LPA ref: 243099

Planning Inspectorate APP/X0360/W/25/3371069

**LAND NORTH OF READING ROAD
ARBORFIELD**

PROOF OF EVIDENCE – LANDSCAPE AND TREES

FIGURE 5 SECTION OF ENGINEERING PLAN ADJACENT TO VETERAN TREES ON READING ROAD

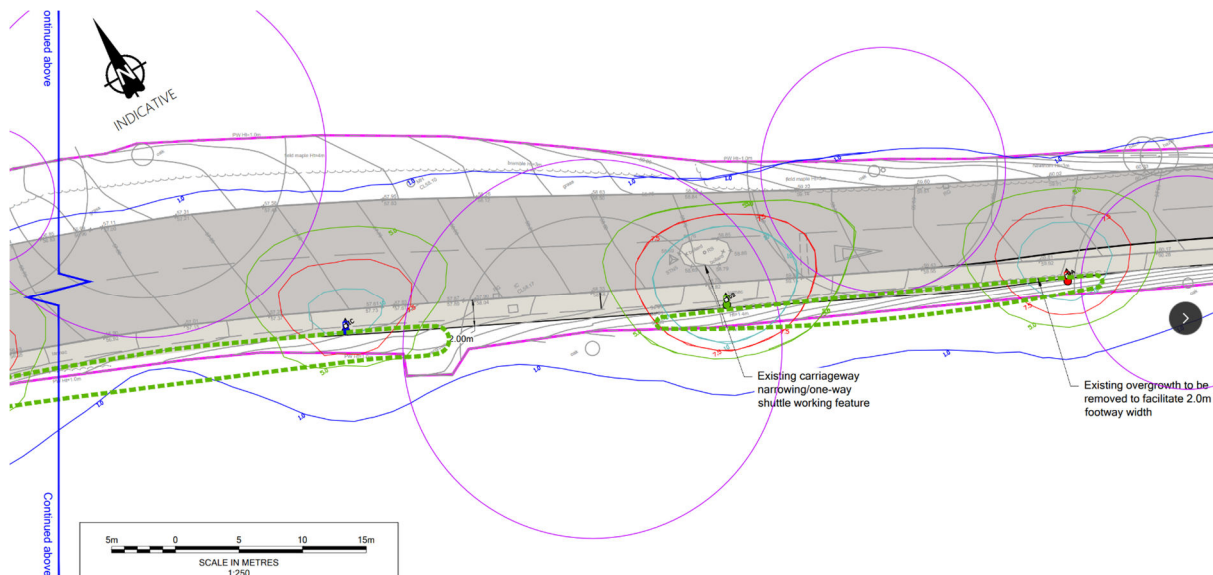
- 6.109 There are, however, the issues of possible physical harm to the aerial parts of veteran tree 163828 when installing 6m street lighting columns (and possible requirements for ongoing canopy management which will cause some harm)

- 6.110 The engineers plan for this section of the road and lighting engineering works is shown in the plan segment below.

6.111 From this plan it will be seen that the lighting column is hard by the canopy shown for tree 163828 and within the Buffer Zone / Root Protection Area for this tree (which should be 15 times the diameter at base height in this case).

6.114 This RPA/buffer is not shown on the highways engineer's plans. The wide purple circle shown, is shown in the engineer's drawing key as the 'Existing Tree Root Protection Area'. However, it can be measured at 15m from the centre of the veteran tree and therefore it seems to be merely the capped

FIGURE 6 GIRTH CHART FOR VARIOUS SPECIES OF TREES FROM 'LONSDALE'

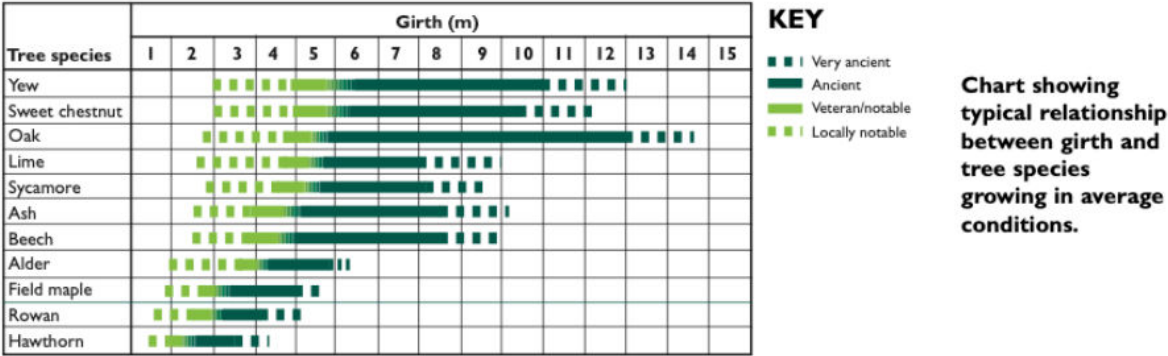
6.138 On size, we have figure 1.3 of LONSDALE. But there is an error in interpretation which crops up from time to time which I address below.

6.139 Some consultants interpret Figure 1.3 incorrectly. Taking the baseline or starting point of the columns on girth at 1m so that for an oak to be an ancient tree the girth must be around 5.7m (where the solid lime green line in the 'Oak' row of the table turns to a solid dark green). The correct interpretation is to read Figure 1.3 with the columns start with the line running down the extreme left of the 'Girth' columns, read as '0'. A clearer visualisation of this is presented below.

FIGURE 8 FIGURE 1.3 MODIFIED AND CLARIFIED TO ACCURATELY REFLECT DR LONSDALE'S EMAIL OF 8TH MARCH 2020

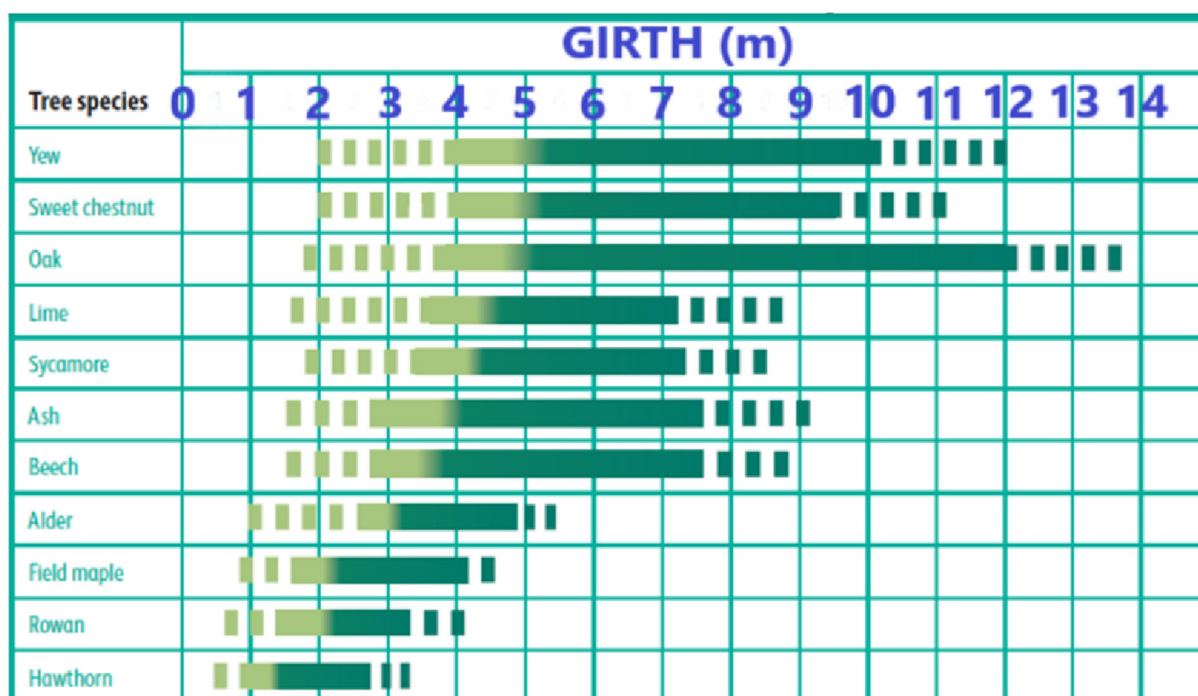
6.146 It is important to note that Dr Lonsdale said: *'an oak could qualify as a veteran with a girth of 3.75 m if it has other qualifying characteristics'*. So then, to edit Figure 1.3 of LONSDALE, with my edits in blue we get a clearer, less ambiguous table:

6.149 Examining the amended unambiguous version of Figure 1.3 we can see that the new Natural England BNG guidance is more in line with this amended version of Figure 1.3 than with the unamended Figure 1.3. Oaks, for example, being seen as ancient tree when they reach 4m girth in the newest NE guidance, 4.7m in the amended Fig 1.3 (incidentally the measurement we used in the Wealden Ancient Tree Survey twenty years ago) as opposed to 5.7 in the unamended Figure 1.3 as it is often (wrongly) interpreted.

6.150 Similarly, smaller oaks (and other species) can be considered veteran in both the NE BNG guidance and the amended Figure 1.3, than in the unamended version.

FIGURE 9 ROUTE OF THE LEOPARD 3 BUS FROM READING TO WOKINGHAM

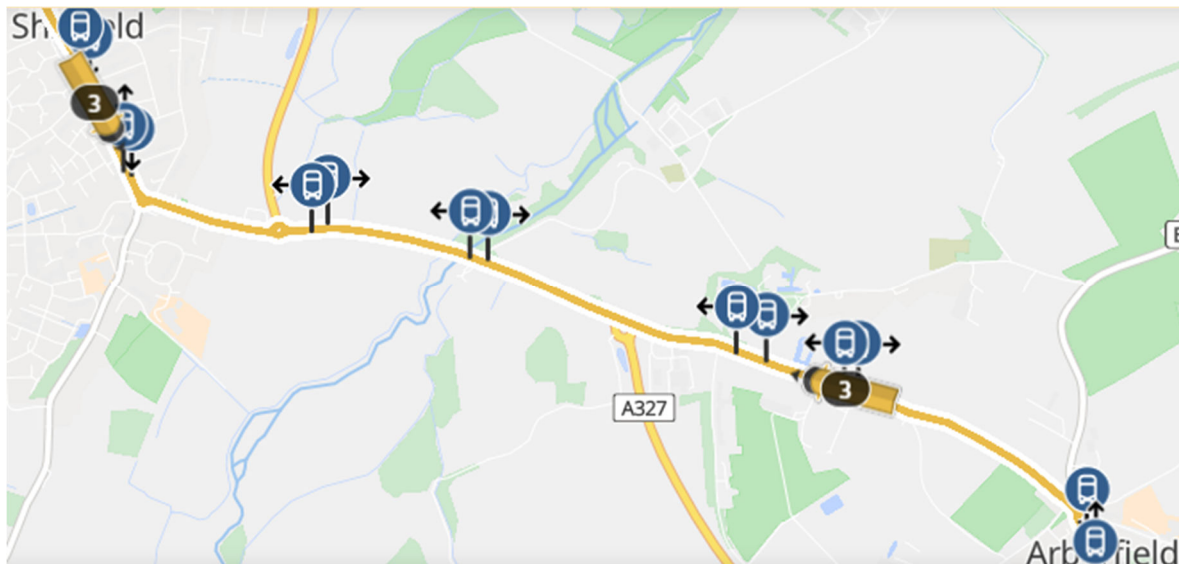
- 7.30 The assessments do not address the impacts and effects of the proposals on those using the Leopard 3 bus route from Reading to Wokingham which runs along Reading Road, stopping at a bus stop at the western end of the site near the Church Lane junction and further east, at the bus stop obliquely opposite the Walden Avenue junction. See map below (the site is just above the right-hand figure '3' in a black circle)

7.31 Passing the 'Arborfield Church Lane' and 'Walden Avenue' stops 49 times a day on the route from Reading to Wokingham, the Leopard 3 runs from 06:01 in the morning to 23:29 at night. On the 'up line' so to speak, from Wokingham to Reading, the Leopard 3 stops at the same two locations, 49 times from 5:52 in the morning to 23:31 at night. The impacts and effects on this element of receptors have not been addressed in the appellants landscape and visual impact assessments.

FIGURE 10 CPRE LIGHT POLLUTION AND DARK SKIES MAPPING OF THE AREA

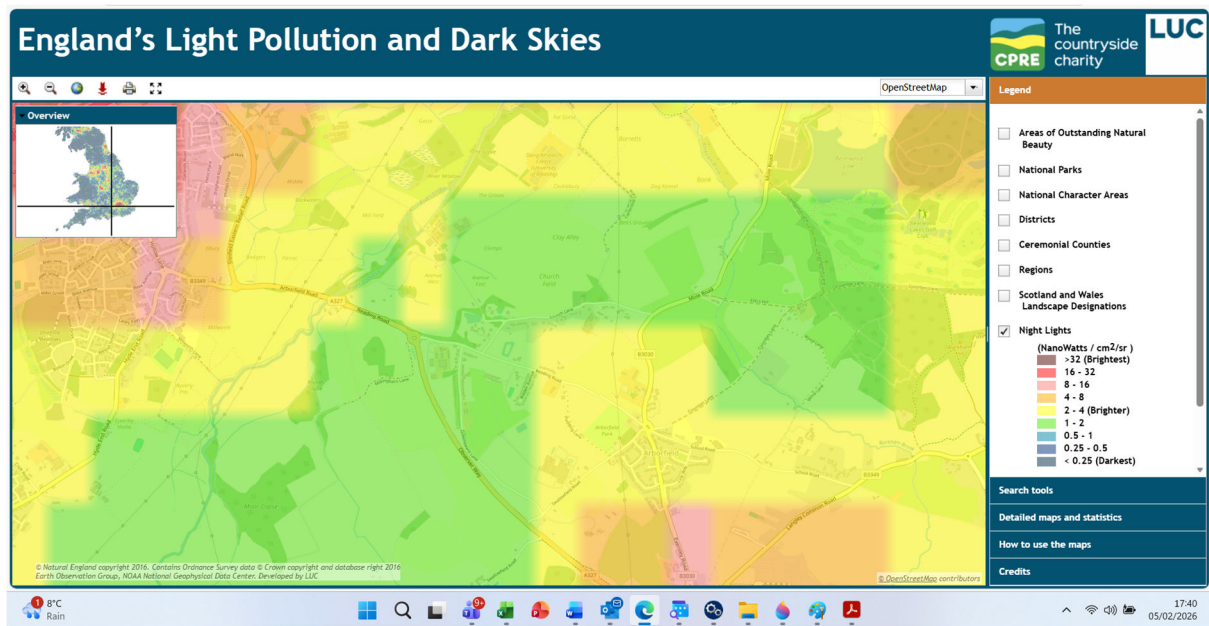
7.37 In addition, inspection of the CPRE tranquillity mapping demonstrates what can still be experienced on site as one travels along Reading Road, that this site sits in an important dark skies hot spot between Arborfield Cross and Shinfield,

FIGURE 11 CPRE DARK SKIES MAPPING (SITE IS CENTRE)

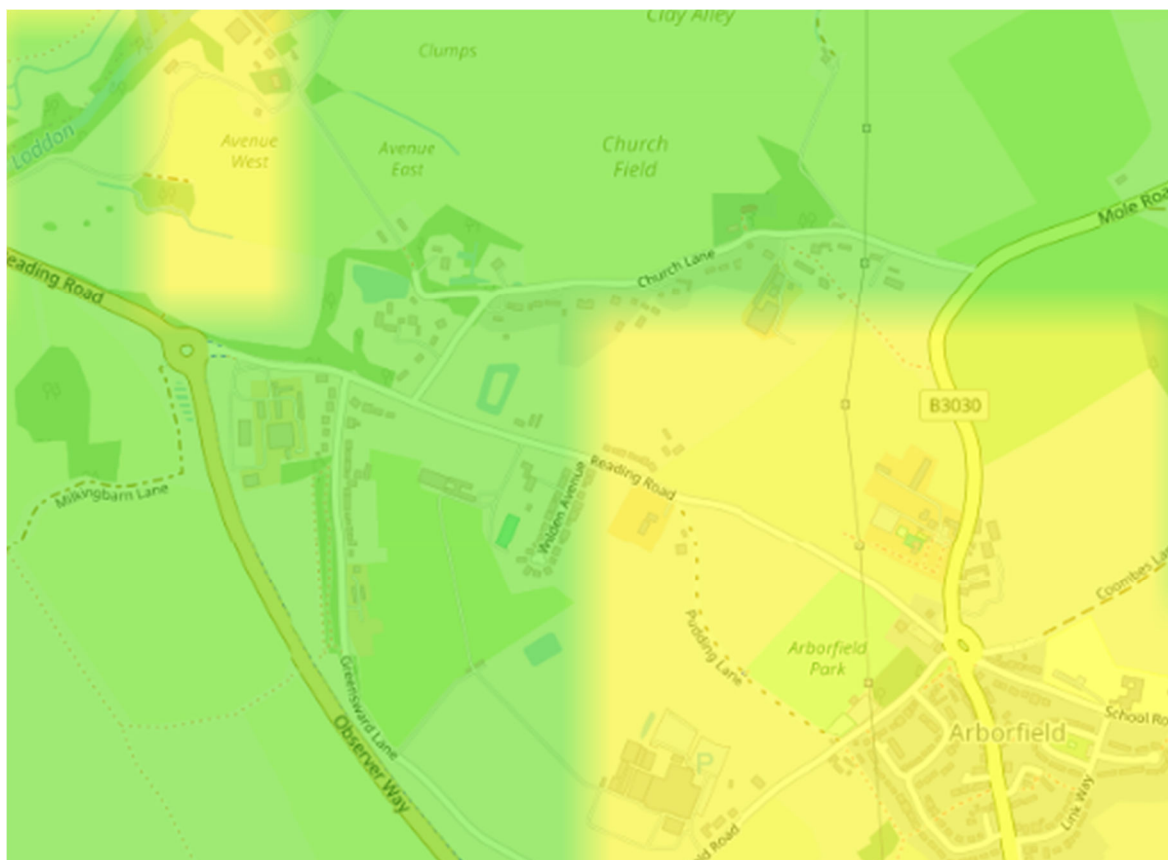
7.38 A close up is shown below.

- 7.39 Importantly Observer Way, the new relief road for Arborfield Cross which can be seen to the SW of the site, only has street lighting at the roundabouts because of the sensitivity of the landscape and because of bats.

FIGURE 12 PROPOSED NEW WALDEN AVENUE BUS STOP

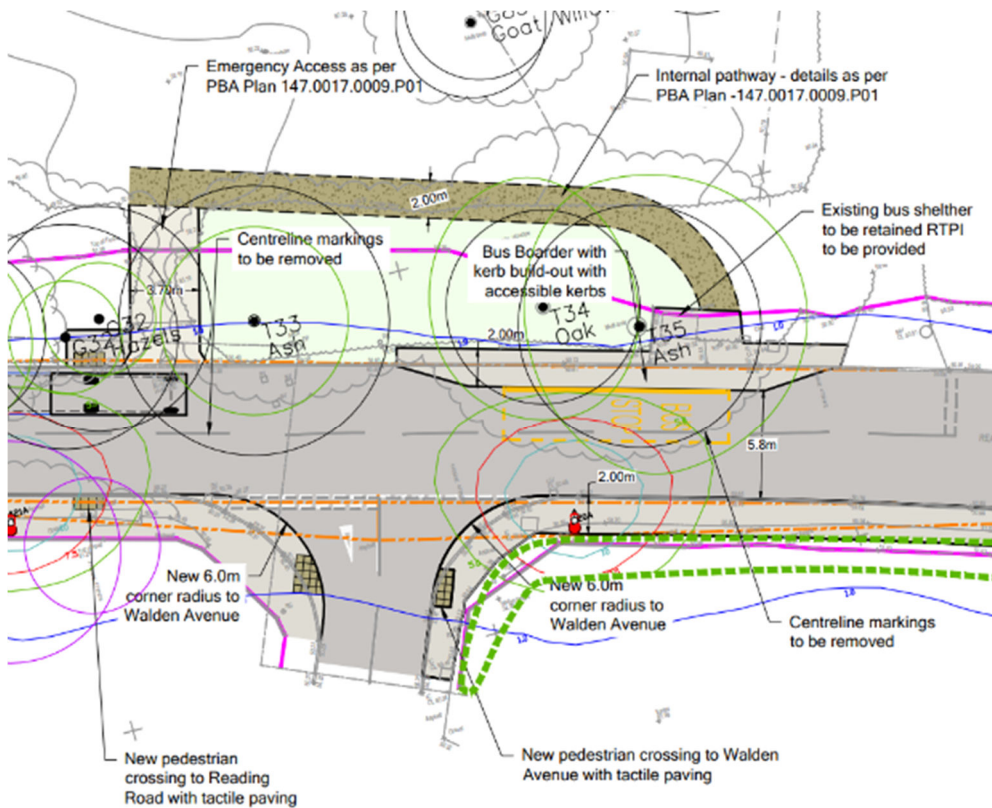
7.58 As well as the landscape and visual impacts of the housing, drainage structures, tree loss, various access points (main vehicular access point, emergency access, pedestrian access) and new bus shelter, the proposals include additional works to the stretch of Reading Road between the bus shelter opposite the entrance to Walden Road and the roundabout at Arborfield Cross. In addition, I understand that a pedestrian crossing traversing Reading Road is now proposed by the existing drop kerbs at the Bull Inn and further drop kerb crossing points will be installed crossing Walden Avenue and also Reading Road at the junction of these two roads. Furthermore, a Bus Boarder with kerb buildout and accessible kerbs proposed for the Walden Avenue stop, whilst important for disabled bus

users, will have a negative impact on the Green Route and the local environment. See figure below.

- 7.59 These works will have a significant and negative cumulative urbanising impact on the Green Route from the site to Arborfield Cross.
- 7.60 It is true that during the day the impacts of the proposed new road works in the section of Reading Road to the E will be, in the main, contained. But 6m lighting columns at regular intervals will be intrusive and urbanising especially when taken with the cumulative impacts of the pavement upgrading. Of course, during the night the lighting will a 'flare path' or miniature 'approach lighting system' linking Arborfield Cross with the site and effectively urbanising and coalescing the site with the settlement.
